Settlers View Subdivision

## An Estate Residential Subdivision in the NE Quarter of Section 23, Township 11 South, Range 66 West of the 6th P.M., El Paso County, Colorado

Revise to Preliminary Plan  
Add: PCD File No.: SP-17-006

SETTLERS VIEW SUBDIVISION  
Preliminary Plat  
El Paso County, Colorado

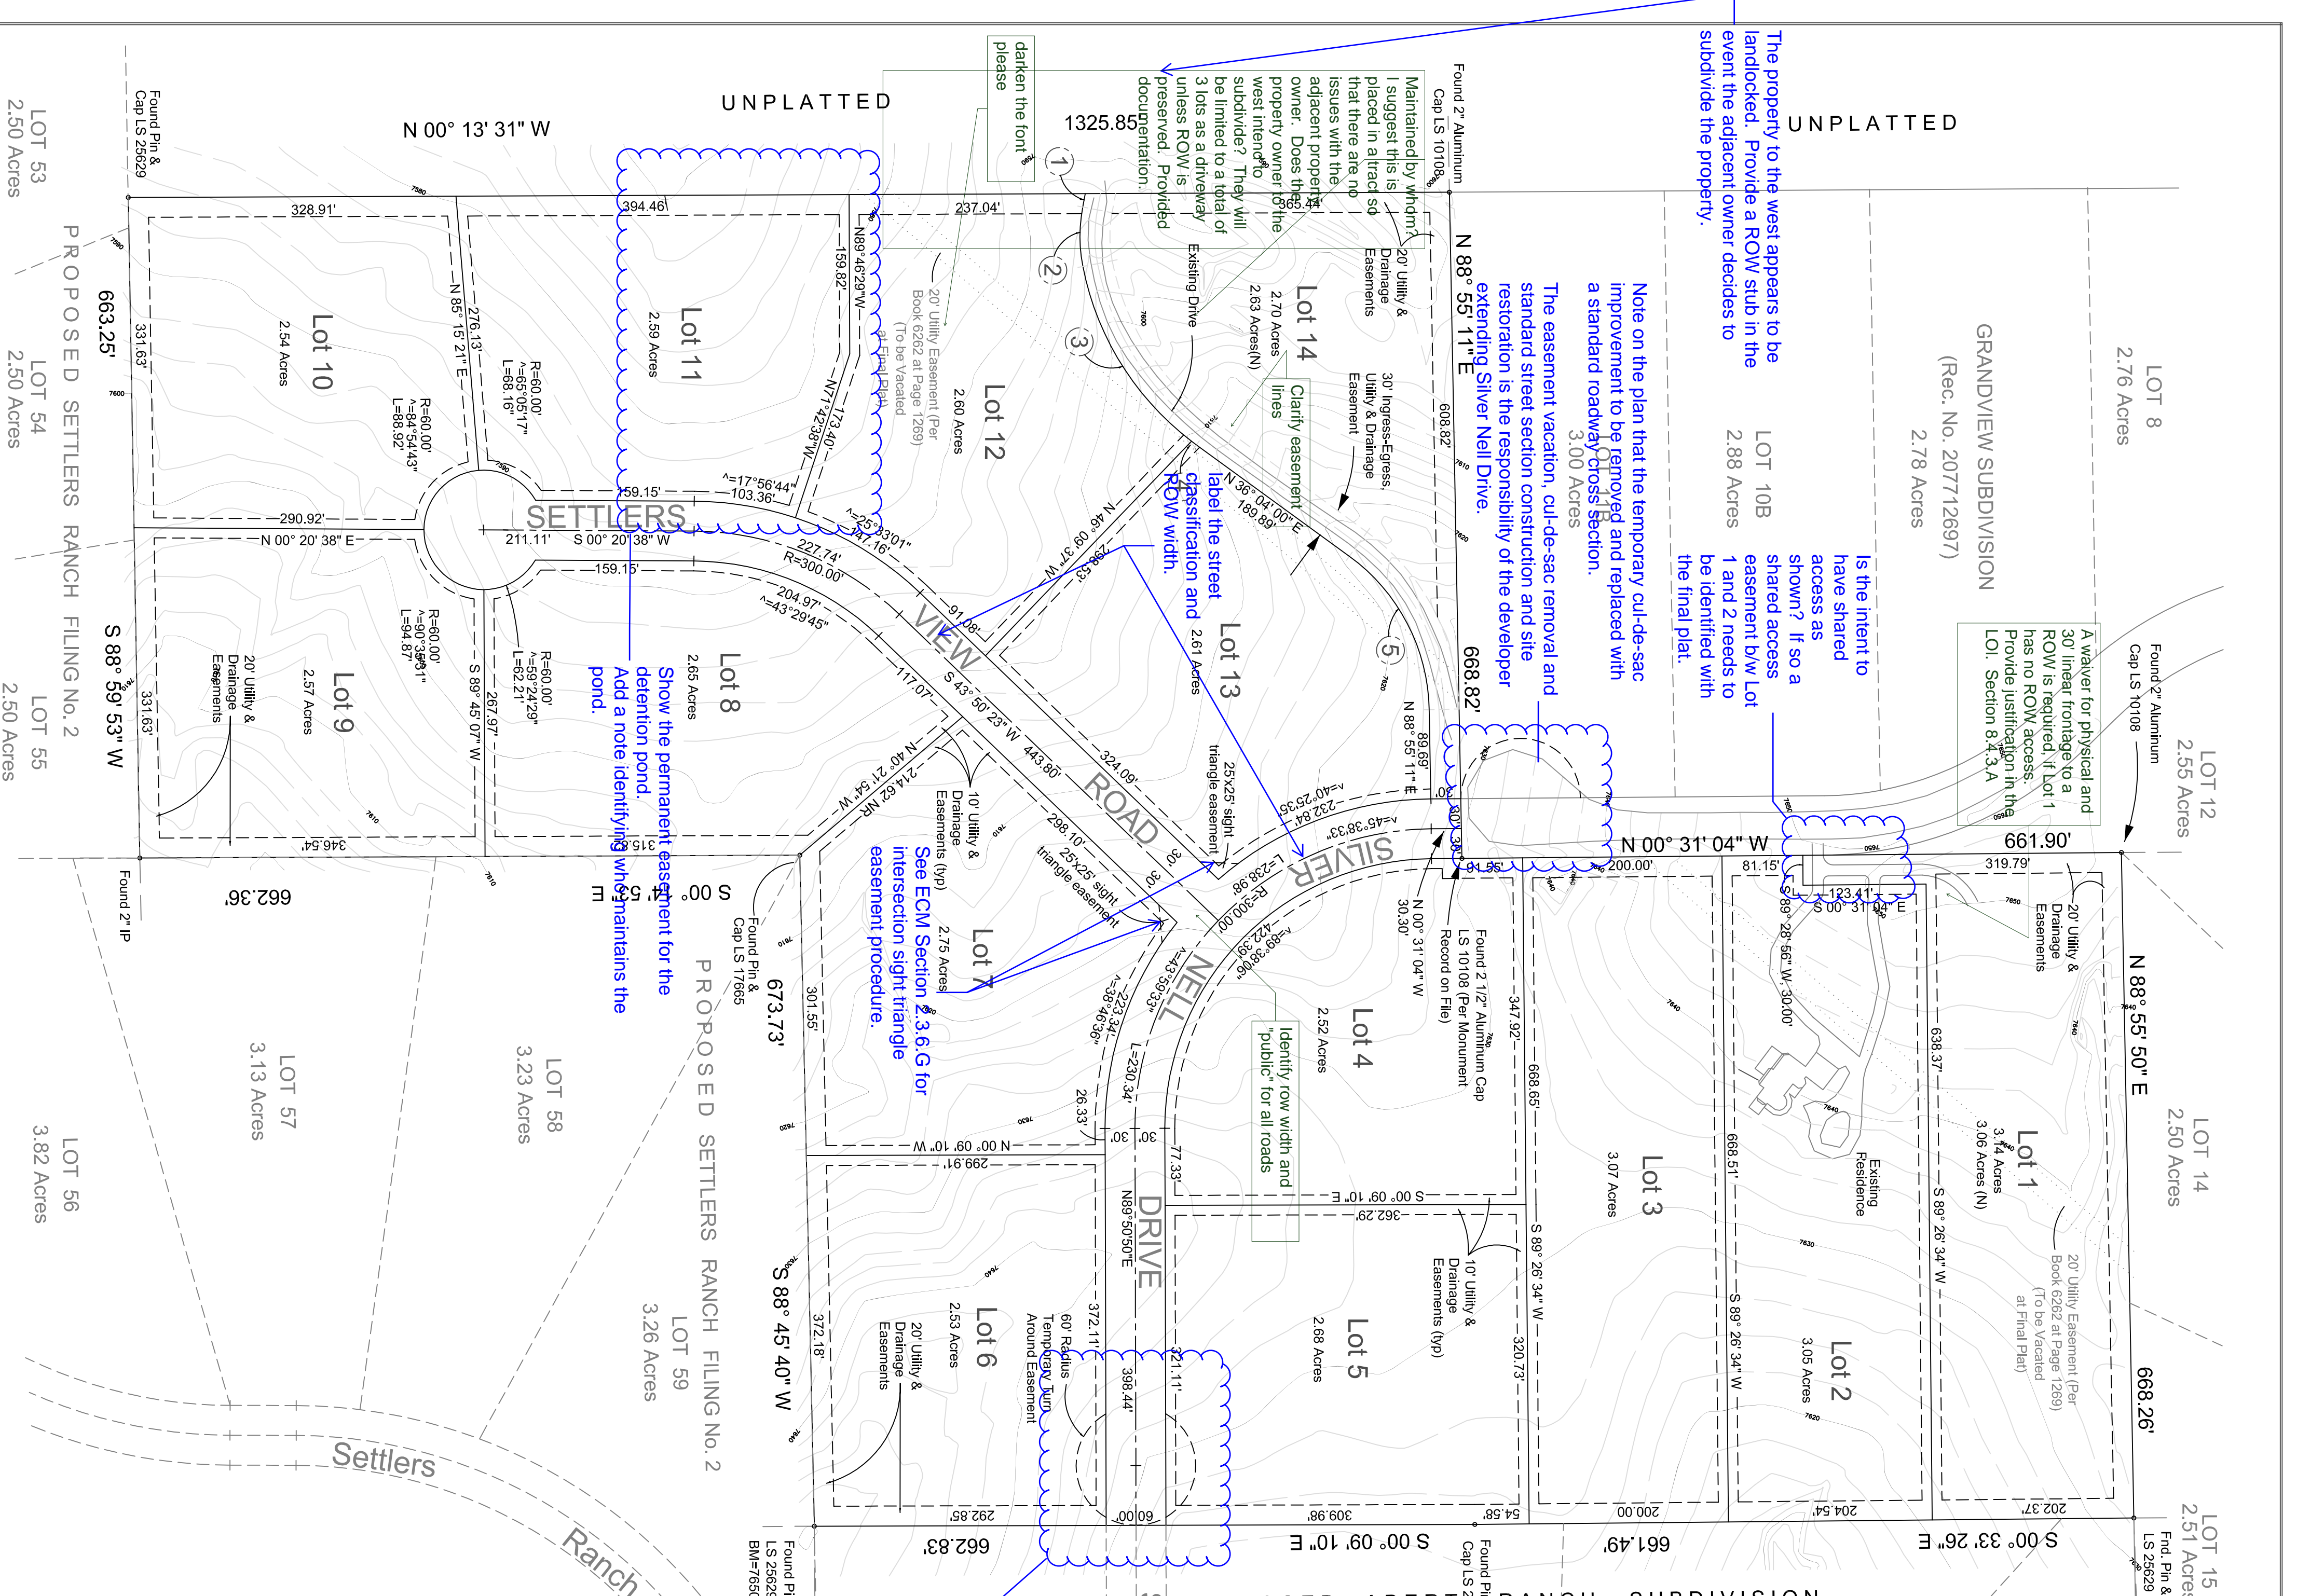
Identify the adjacent zoning and land uses for all boundaries. The east boundary will have existing and proposed.

Who are the utility providers to be? Add notes.

Add a typical roadway cross section detail. Per the EPC standard detail for Rural Local Roadway, a 5' public improvement along the ROW shall be granted to El Paso County.

Add note regarding western access easement.

Delete proposed. The rezone will be approved prior to the prelim.

Add Geologic hazard note provided in MTD letter. Identify the hazard areas on map.

Revise to Preliminary Drainage Report.

Add the correct language for the temporary cul-de-sac identified in ECM Chapter 2, Section 2.3.8, C (pg 2-63). The note must also be added in the final plat.

The property to the west appears to be landlocked. Provide a ROW stub in the event the adjacent owner decides to subdivide the property.

Is the intent to have shared access as shown? If so a shared access assessment b/w Lot 1 and 2 needs to be identified with the final plat.

Note on the plan that the temporary cul-de-sac improvement to be removed and replaced with a standard roadway cross section.

Classify the street as a driveway with a ROW width.

See ECM Section 2.3.6 G for intersection sight triangle easement procedure.

Show the permanent easement for the definition pond. Add a note identifying what maintains the pond.

label the street classification and ROW width.

Identify row width and "public" for all roads

Maintained by whom? I suggest this is placed in a tract so that there are no issues with the adjacent property owner. Does the property owner to the west intend to subdivide? They will be limited to a total of 3 lots as a driveway unless ROW is preserved. Provided documentation.

Clarify easement lines

A waiver for physical and 30' linear frontage to a ROW is required, if Lot 1 has no ROW access. Provide justification in the LOI. Section 8.4.3.A

Where is the flag lot?

Add note: Water Supply: (utilized when the water supply is individual wells)  
(Note: The exact wording of plat notes regarding well water supply depends upon the language of the water decree and/or augmentation plan, and will be reviewed and approved by the County Attorney's Office)  
Individual wells are the responsibility of each property owner. Permits for individual wells must be obtained from the State Engineer who by law has the authority to set conditions for the issuance of these permits.  
Water in the Denver Basin Aquifers is allocated based on a 100-year aquifer life; however, for El Paso County planning purposes, water in the Denver Basin Aquifers is evaluated based on a 300-year aquifer life. Applicants and all future owners in the subdivision should be aware that the economic life of a water supply based on wells in a given Denver Basin Aquifer may be less than either the 100 years or 300 years indicated due to anticipated water level declines. Furthermore, the water supply plan should not rely solely upon non-renewable aquifers. Alternative renewable water resources should be acquired and incorporated in a permanent water supply plan that provides future generations with a water supply.

Add note: Sewage treatment is the responsibility of each individual property owner. The El Paso County Department of Health and Environment must approve each system and, in some cases the Department may require an engineer designed system prior to permit approval. These systems may cost more to design, install, and maintain.

Depending on the timing between Settlers View and Abert Ranch, the first developer to construct will be required to install the temporary cul-de-sac at the interface between the two developments while the second developer will be required to remove the temporary cul-de-sac when the connection is made. temporary cul-de-sac may not be required.

The easement vacation, cul-de-sac removal and standard street section construction and site restoration is the responsibility of the developer extending Silver Neil Drive.
